**WIND GARDEN WIND FARM, EASTERN CAPE PROVINCE  
(DFFE Reference No.: 14/12/16/3/3/1/2314)**

**COMMENTS AND RESPONSES REPORT**

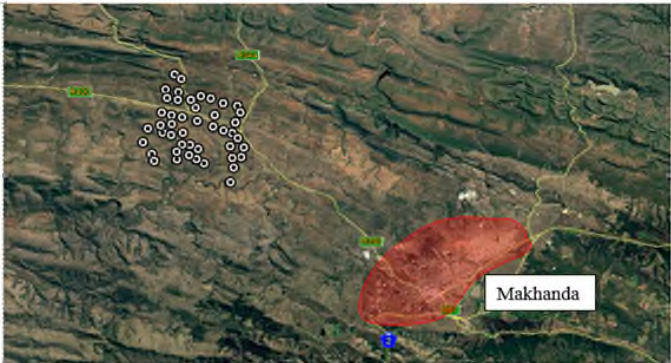
No.	Comment	Raised by	Response
	<p>7. The proposed buffers for Martial Eagle nests are also significantly less than recommended in most other impact assessments (i.e. 5-6 km). Van Eeden et al. (2017) 's research tracking Martial Eagles in the Kruger indicated a 50% Kernel Density with an average of 16.5km<sup>2</sup> - which would suggest a buffer with a radius of 2.9 km from a nest would be necessary to avoid just the core territory. Martial Eagle territories are likely to be much larger in the area of the proposed development.</p>		<p>residual collision risk will remain. That will remain the case however much modelling and analysis is carried out, as both Murgatroyd et al's work and the specialist's local studies have shown that these birds range widely from their nests. Avoiding the close proximity to nests can reduce the risk, but not remove it altogether.</p> <p>This follows on from the same principle as above, where Murgatroyd et al highlighted the limited benefit of simple circular buffers and their inefficiency in defining areas of higher collision risk, as these eagles do not randomly move around a specific distance from their nests but choose to forage and fly over specific areas and habitats within their range. The spatial modelling undertaken by the specialist has shown the importance of distance from the nest, but also altitude (higher flight activity in the 600-800m range), distance from ridge lines (higher closer to ridge lines), and slope (higher in areas of steeper slope).</p> <p>In relation to the design of the site buffers, the analysis used to inform the 2.5km distance for Martial Eagle is set out in Appendix 2 of the AIA (Appendix E of the BAR). Figure 1 from that appendix is reproduced here as it illustrates the evidence base for the use of that specific distance. The survey data showed a strong relationship between flight density and distance from the nest, but this relationship flattened out beyond 2.5km. The highest densities were recorded within 500m of nests and there was a steady decline in flight density with distance from the nest, but only up to a distance of 2.5km. Beyond 2.5km flight density was consistently lower. A ny exclusion of turbines beyond 2.5km would be of much less benefit in reducing collision risk. A similar result was found for the Choje East Block, though</p>

No.	Comment	Raised by	Response																																						
			<p>there, higher flight activity was noted within 1.5km of the nest (though with a smaller amount of baseline data available a precautionary approach was adopted and a 2.5km applied in the East and as well as the West).</p> <p><i>Appendix 2. Figure 1. Martial Eagle flight density and distance from the nest, Choje West June 2019 - August 2020 (mean ± 95% confidence limits).</i></p>

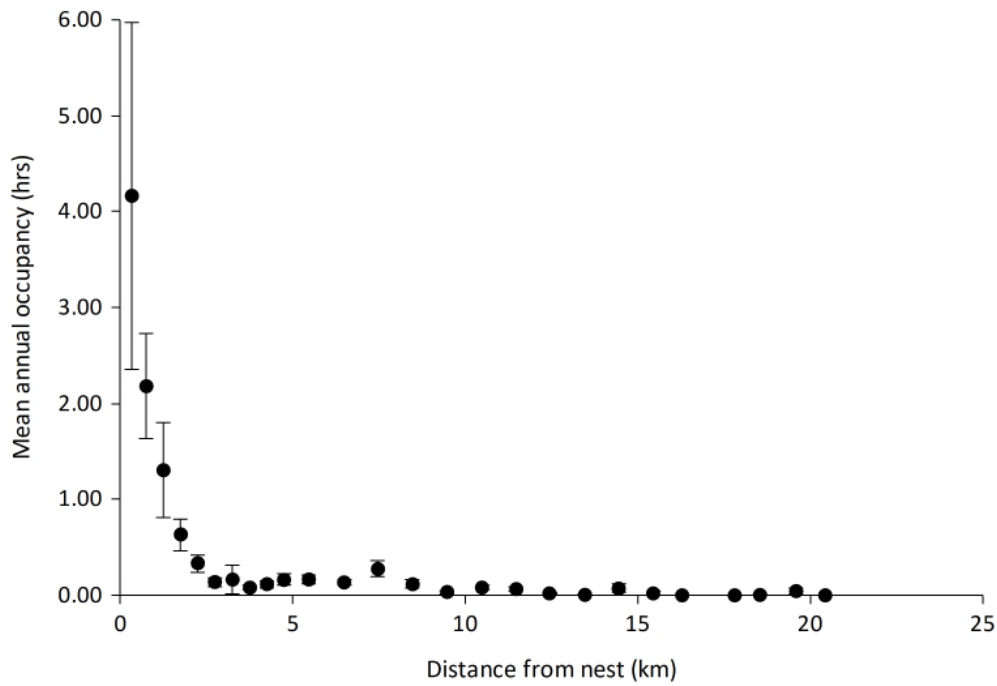
Concerns are raised about the amount of VP data. There has though been a very considerable amount of surveys (900 hours over the Wind Garden/Fronteer study area as a whole, i.e. the area indicated in Figure 3 of the report). The lack of records flying through the collision risk zone was not a result of a lack of survey effort but rather reflect the very low use that these species made of the zone.

Assertions about the quality of VP data ignore the fact that this is a well-proven methodology that has been adopted worldwide to assist in wind farm collision risk analysis. To describe rigorously collected VP data as ‘notoriously unreliable’ is at best disingenuous, if not misleading.
